THE VILLAGE AT ENCINO PARK
 P.O.A.D.P. / P.U.D. PLAN
 5/1

Re: Village at Encino Park

POADP # 268-B

The City Staff Development Review Committee has reviewed Village at Encino Park Subdivision Preliminary Overall Area Development Plan # 268-B. Please find enclosed a signed copy for your files. Although your plan was accepted, please note the following:

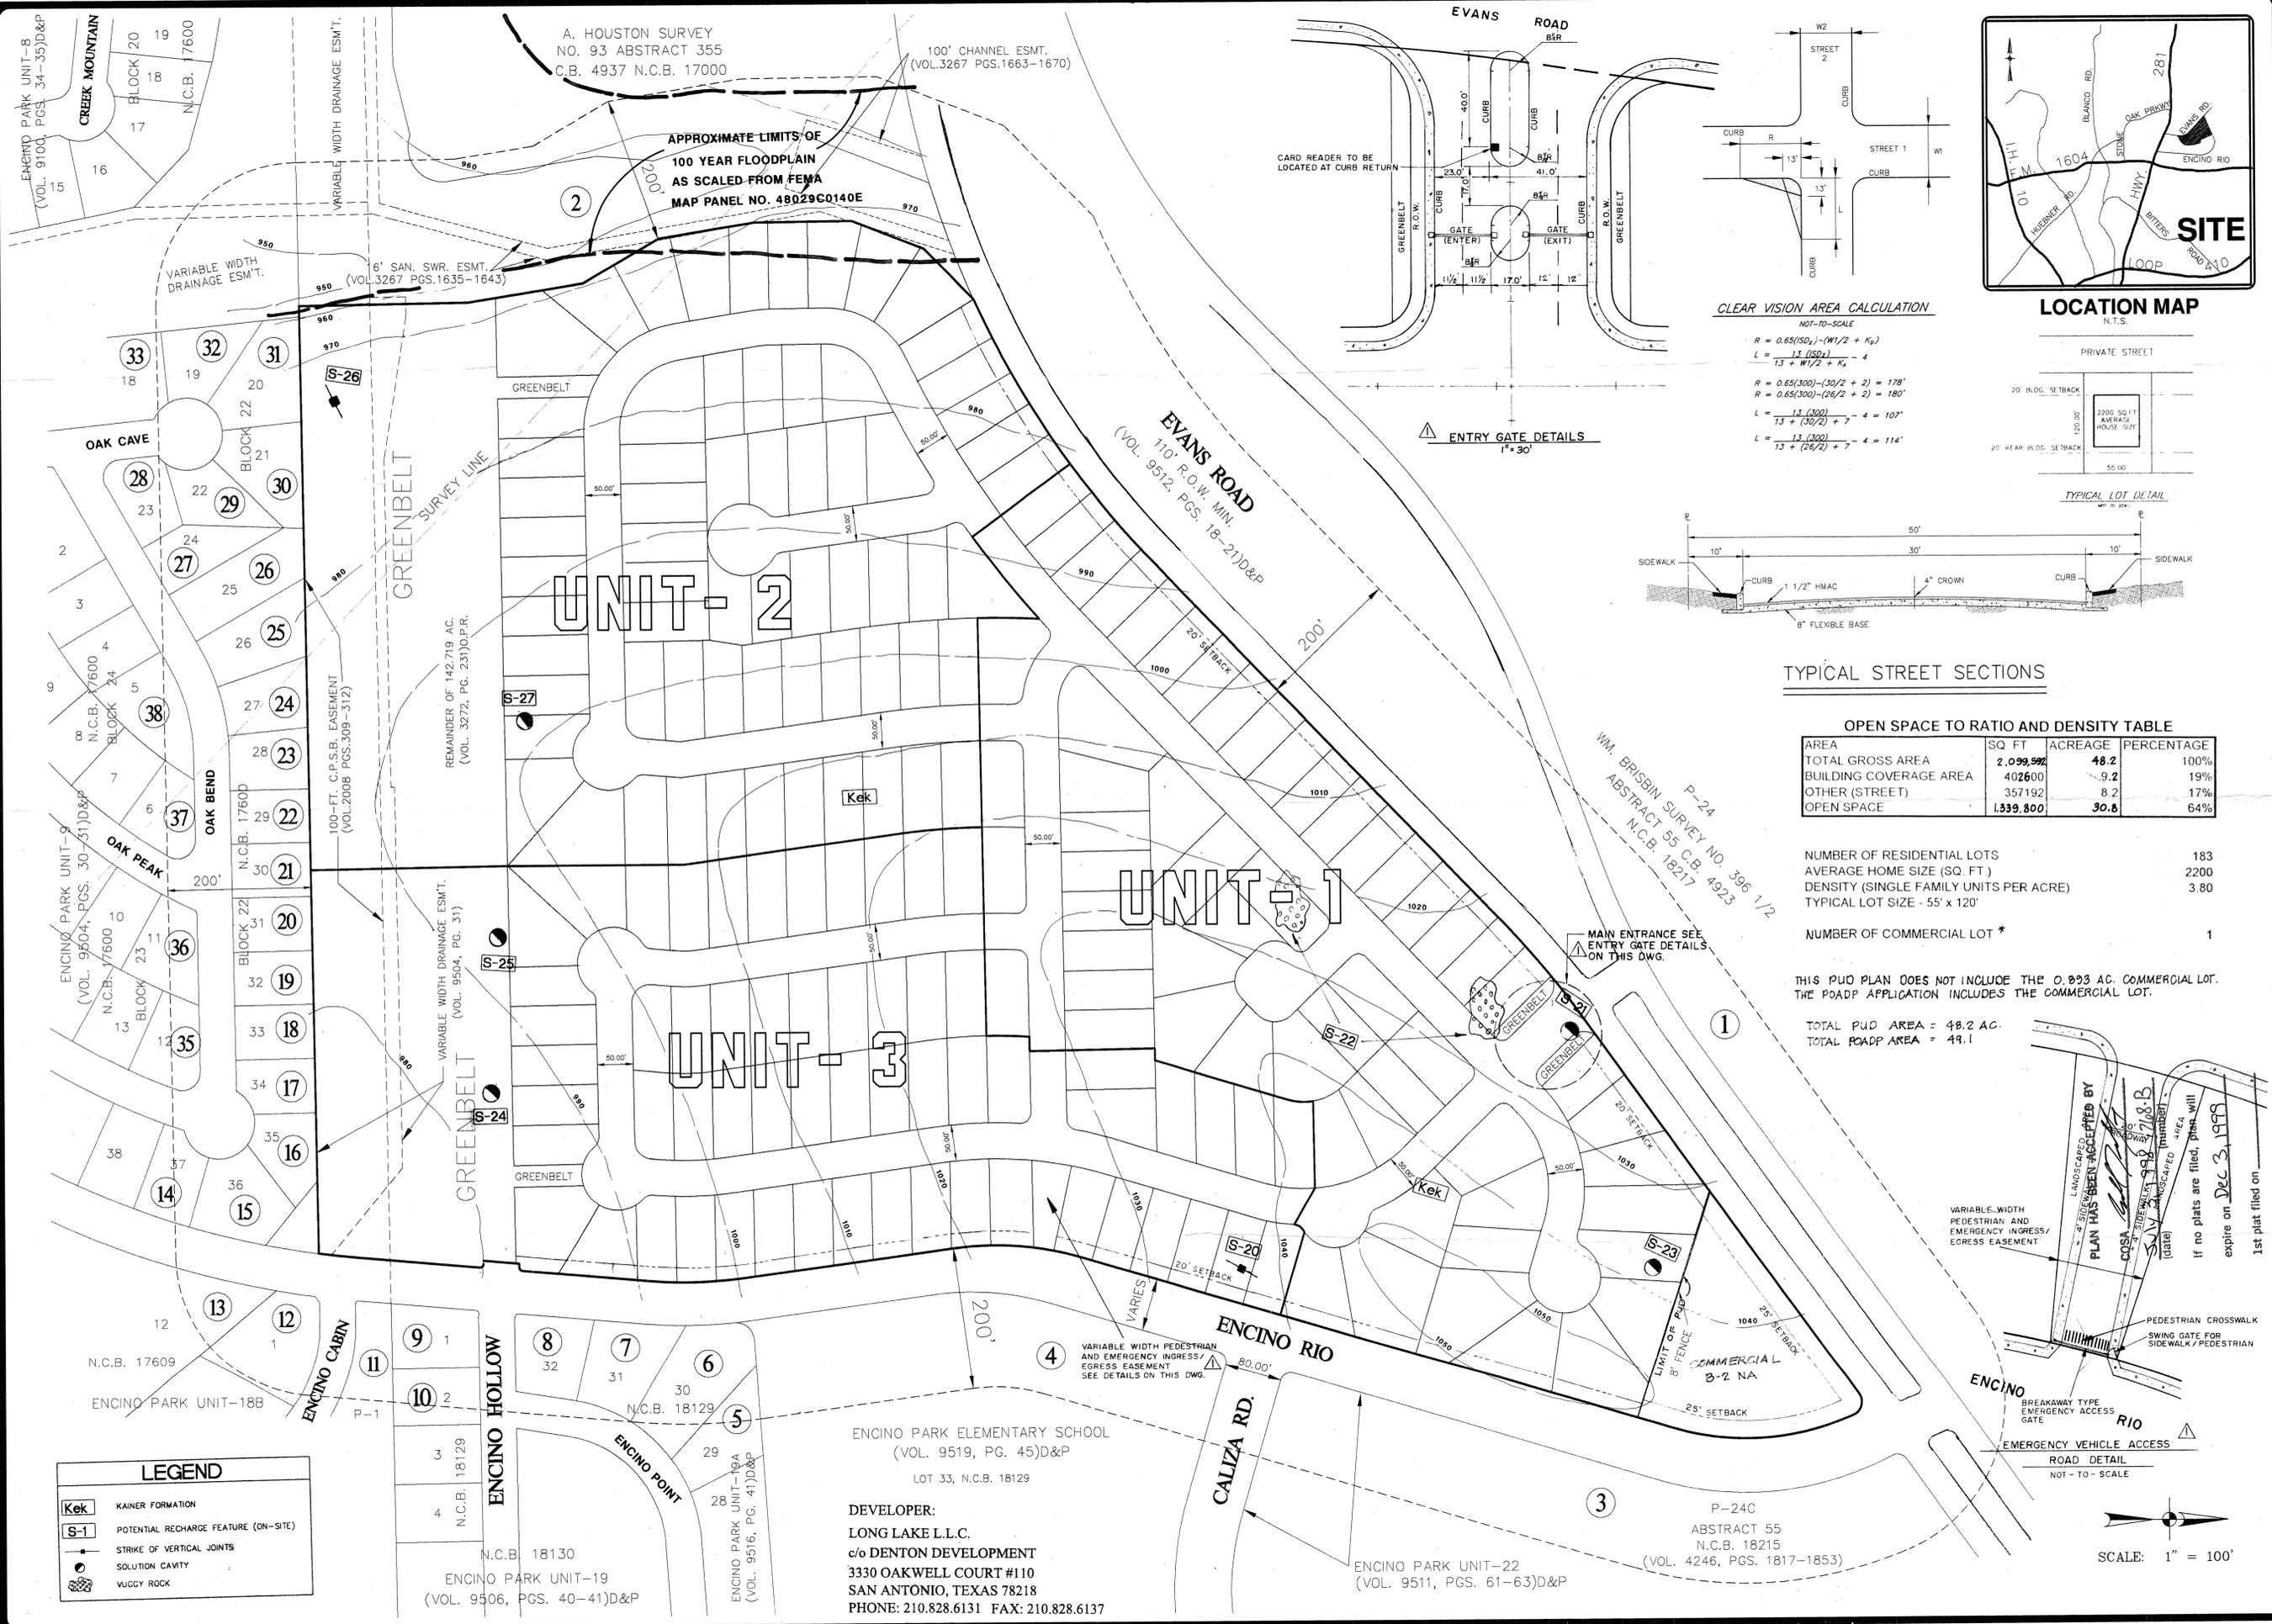
- Based on the topography, a Flood Plain Study and drainage review will probably be required during the platting process.
- This development will probably need to conform to requirements associated with development over the Edwards Aquifer. For additional information about these requirements you can contact SAWS at 704-7305.
- This development will need to comply with tree preservation ordinance #85262. For information about these requirements you can contact Building Inspections at 207-7102.
- It will be expected that you will plat all of the property depicted in your POADP, to include: floodpains, drainage areas and open space.
- I would encourage you to work closely with the school district, so they can plan accordingly.
